PROPOSED CHANGES TO
ENDORSED DRAWINGS

PROPOSED ALTERATIONS & ADDITIONS
TO VSL SKI CLUB
CHAMOIS ROAD
MT BULLER

AMENDMENTS TO ENDORSED PLANS

FURTHER AMENDMENTS TO ENDORSED PLANS

DRAWING
PROPOSED FLOOR PLANS

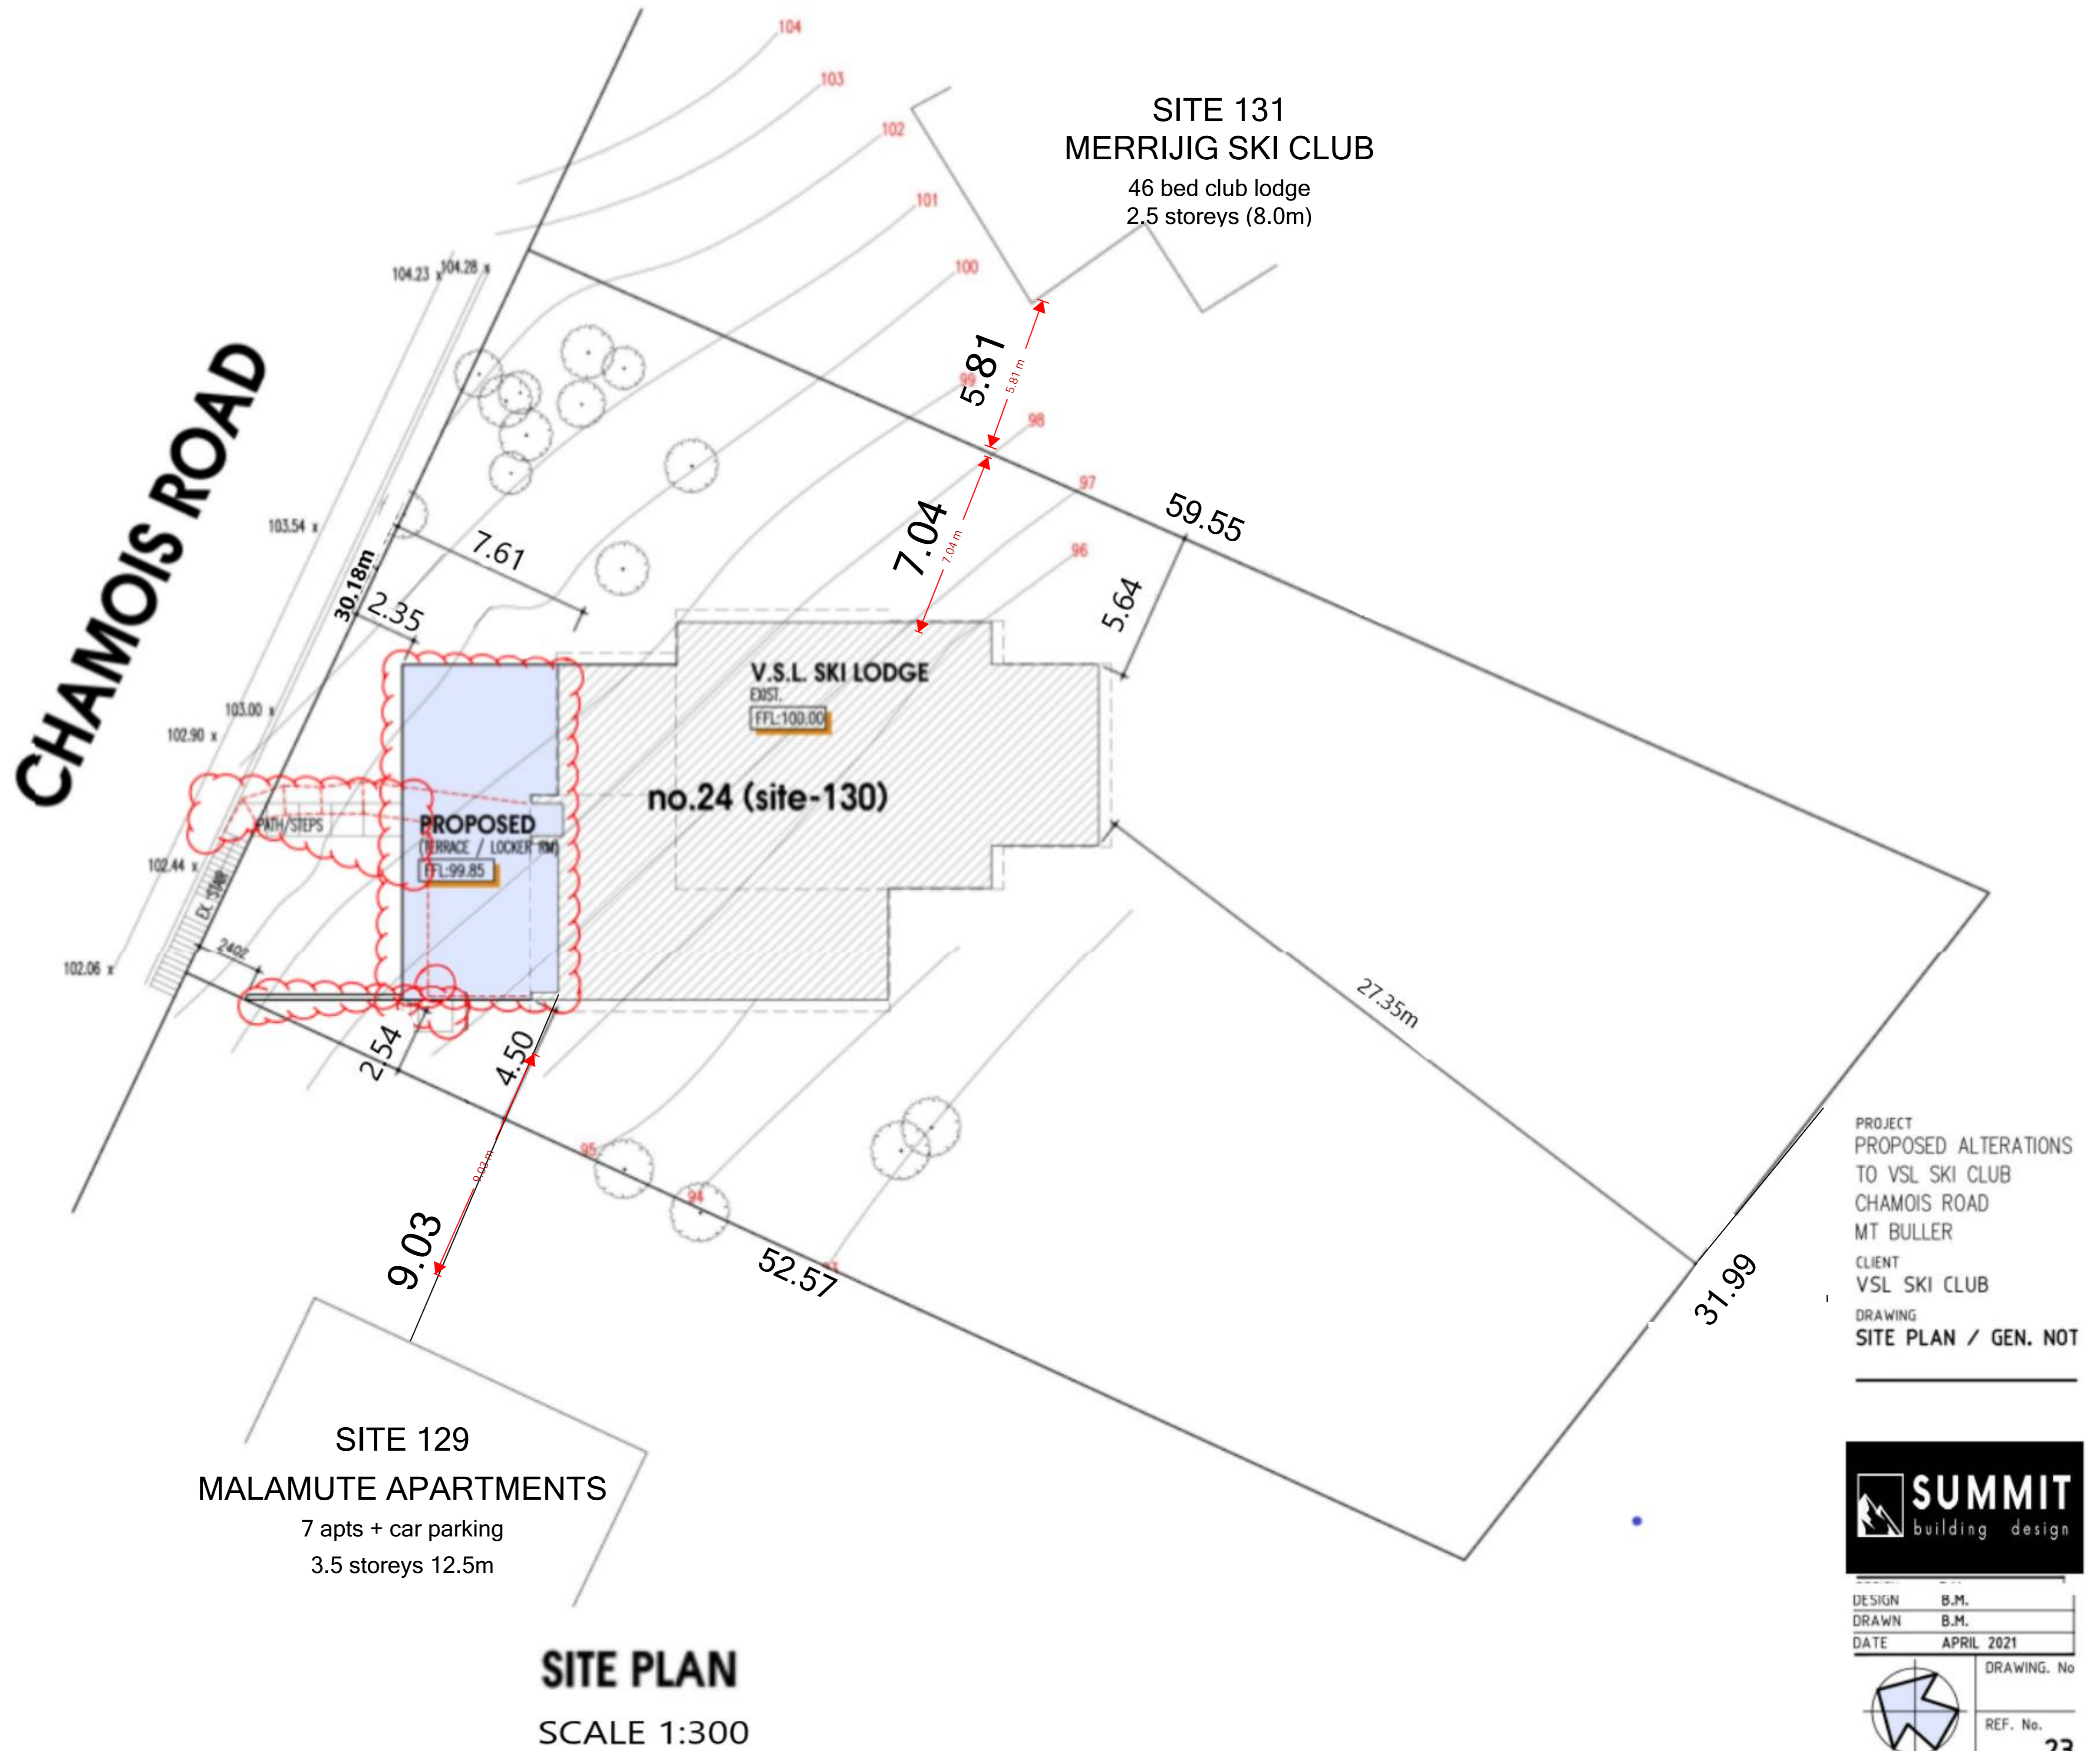
1. DELETE STAIR ON NORTH FACADE OF EXTENSION PROVIDING ACCESS FROM DECK
2. DELETE ENTRY DOOR IN NORTEHRN FACADE PROVIDING ACCESS INTO EXTENSION
3. NEW ENTRY DOOR INTO EXTENSION TRHROUGH WESTERN WALL INCLUDING NEW AIRLOCK IMMEDIATELY ADAJCENT
4. EXTEND WESTERN WALL FROM EXTENSION TO SITE BOUNDARY (SAME HEIGHT AS EXTENSION) TO FUNCTON AS RETAINING WALL
5. AREAS ABUTTING NORTH AND EAST WALLS OF EXTENSION TO BE BACKFILLED TO DECK HEIGHT I.E.WALLS COMPLETELY COVERED

1. DELETE PEDESTRIAN "BRIDGE" PROVIDING ACCESS TO EXTENSION ROOF/DECK FROM NORTH
- 2.. INCLUDE NEW HEATED CONCRETE PATH/STEPS FOR AT GRADE PEDESTRIAN ACCESS TO
EXTENSION ROOF/DECK
2. DELETE STAIR PER LEVEL1 COMMENTS
3. EXTEND BALUSTRADE ON WESTERN RETAINING WALL TO COMPLY WITH REGULATIONS
4. DELETE BALUSTRADES ON NORTH AND EASTERN EDGES OF EXTENSION ROOF/DECK

EAST ELEV.
SCALE 1:250

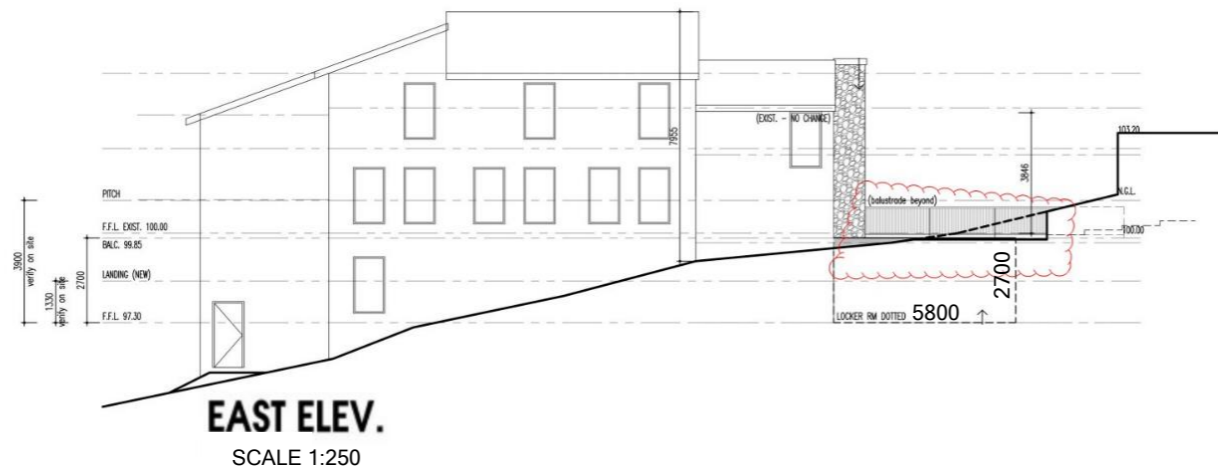
1. EXTEND BALUSTRADE FROM DECK ALONG WESTERN RETAINING WALL IN COMPLIANCE WITH REGULATIONS
2. DELETE BALUSTRADE FROM NORTHERN AND EASTERN EDGES OF DECK (TO BE BACKFILLED TO DECK HEIGHT)

WEST ELEV.
SCALE 1:250

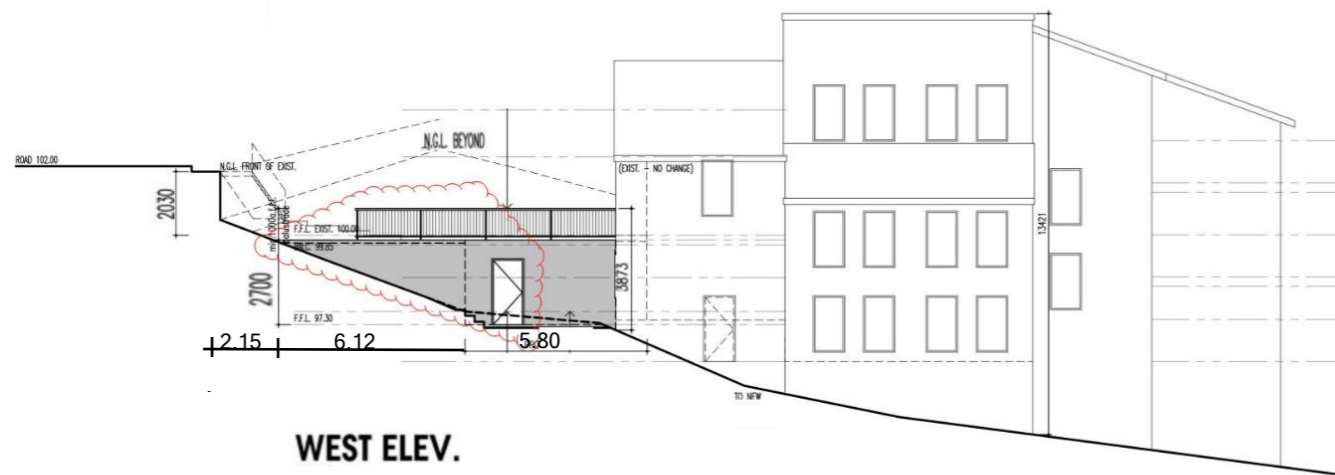
1. EXTEND WESTERN WALL AT DECK HEIGHT TO SITE BOUNDARY TO FUNCTION AS RETAINING WALL FOR BACKFILL
2. INSTALL ENTRY DOOR IN WESTERN WALL OF EXTENSION
3. EXTEND BALUSTRADE ALONG WESTERN WALL TO ENSURE COMPLIANCE WITH SAFETY REGULATIONS

A-A SECTION

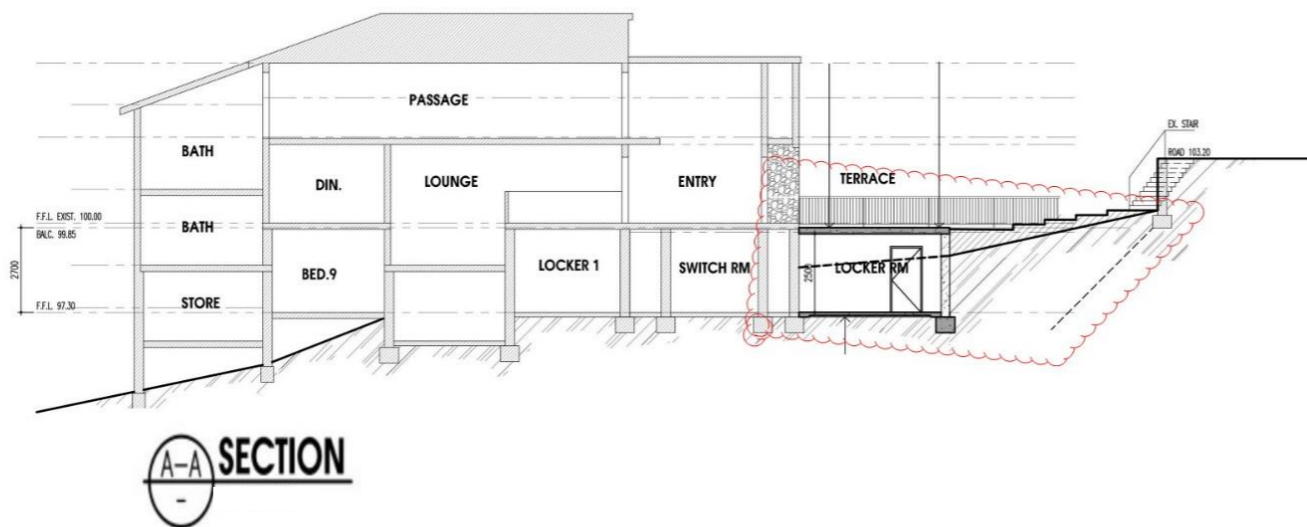
1. DELETE PEDESTRIAN "BRIDGE" AND STAIRS TO LOWER LEVEL VOID; AREA B/W NORTH FACADE OF EXTENSION AND NORTH BOUNDARY TO BE BACKFILLED TO DECK HEIGHT (EASTERN & NORTHERN WALLS FULLY COVERED)
2. NEW HEATED CONCRETE PATH AND STEPS AT GRADE

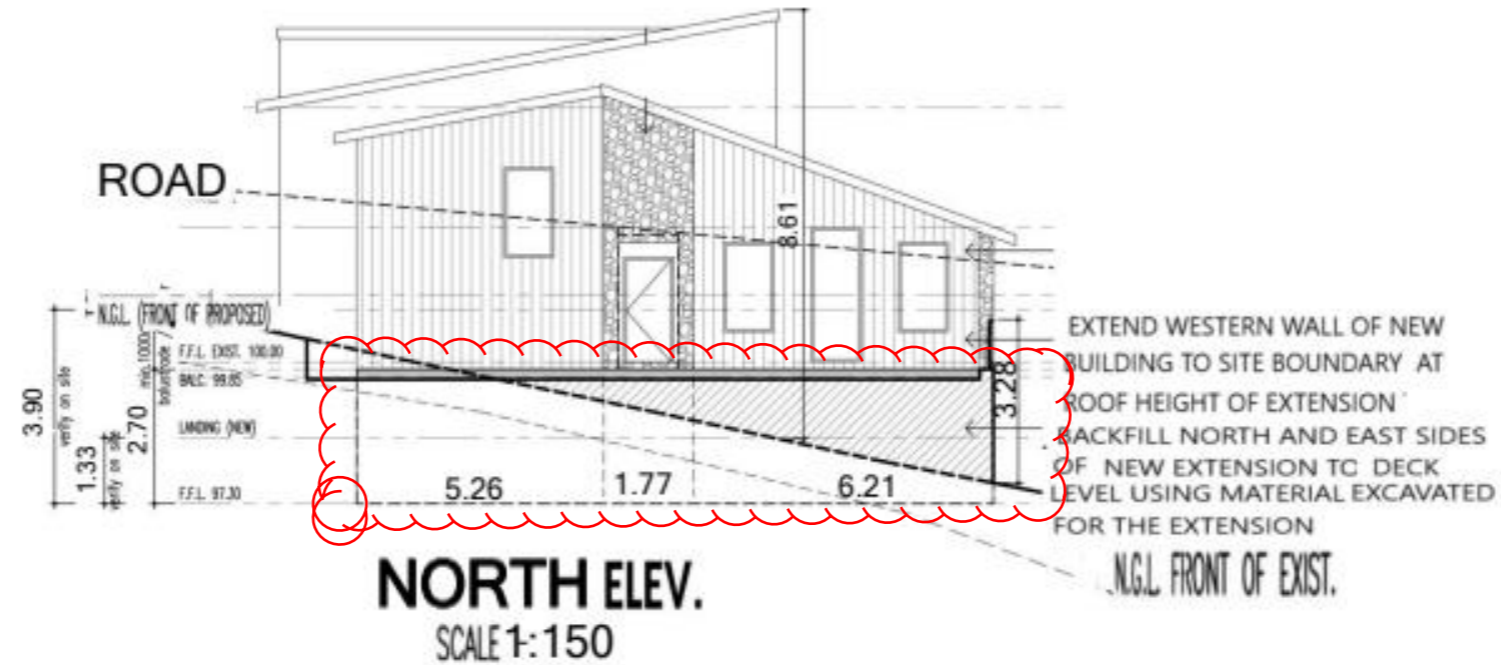
1. CONTINUE BALISTRAD FROM ROOF DECK OF EXTENSION TO WESTERN RETAINING WALL TO COMPLY WITH REGULATIONS
2. REMOVE BALUSTRAD FROM NORTH AND EAST EDGES OF ROOF DECK OF EXTENSION
3. REMOVE STAIRS FROM FRONT (NORTH SIDE) OF EXTENSION.
4. RELOCATE ENTRANCE DOOR FROM FRONT (NORTH SIDE) TO WEST SIDE OF EXTENSION.
- 5 REPLACE PEDESTRIAN "BRIDGE" PROVIDING ACCESS FROM CHAMOIS RD FRONTAGE, WITH HEATED CONCRETE PATH / STEPS.
- CONNECTING STAIR B/W STRUCTURE AND ROAD NOT SHOWN TO MAINTAIN CLARITY

SITE REHABILITATION & REVEGETATION PLAN

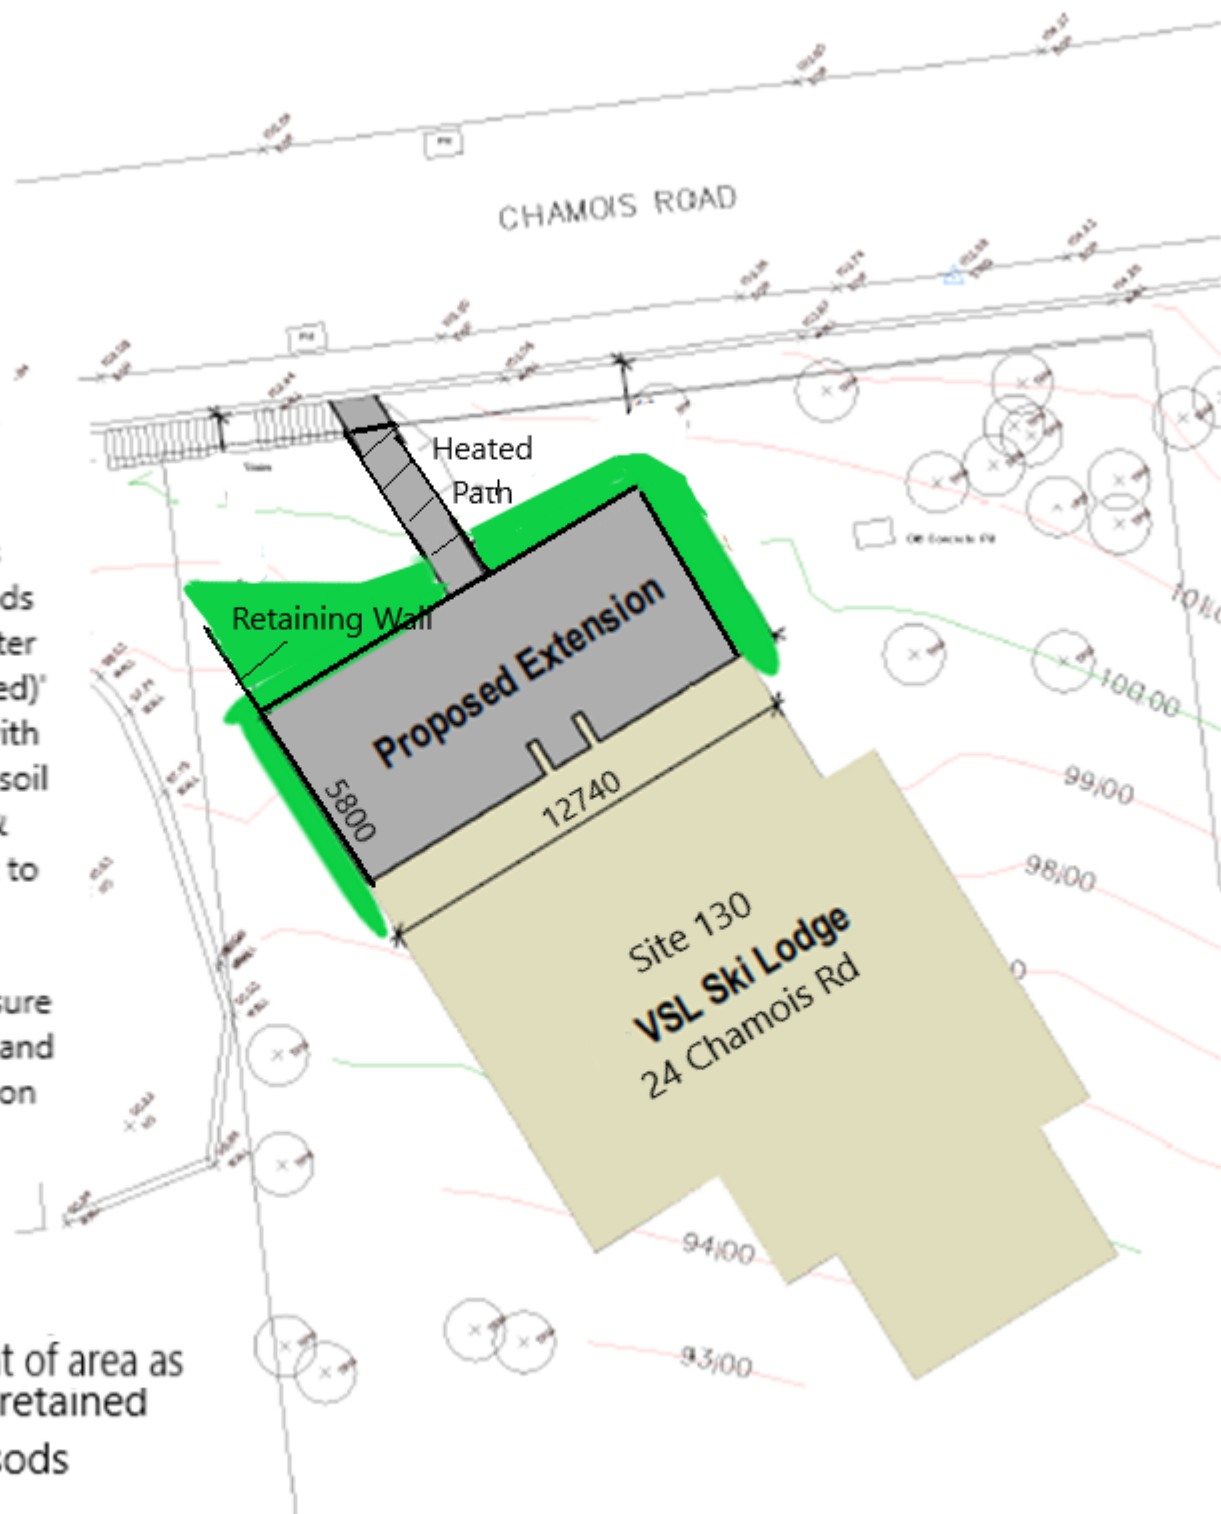
1. Retain topsoil & grass sods removed when footprint of extended deck excavated.
2. After deck construction has been completed, topsoil & sods can be placed around perimeter (with mulch & mesh, if required)
3. Sodds used in conjunction with mulch and mesh will assist in soil retention and reduce runoff & siltation, and act as a blanket to assist in germination of revegetated ground cover.
4. Site to be monitored to ensure germination of ground cover and maintenance of soil stabilisation measures.

Revegetate extent of area as required using retained topsoil & grass sods
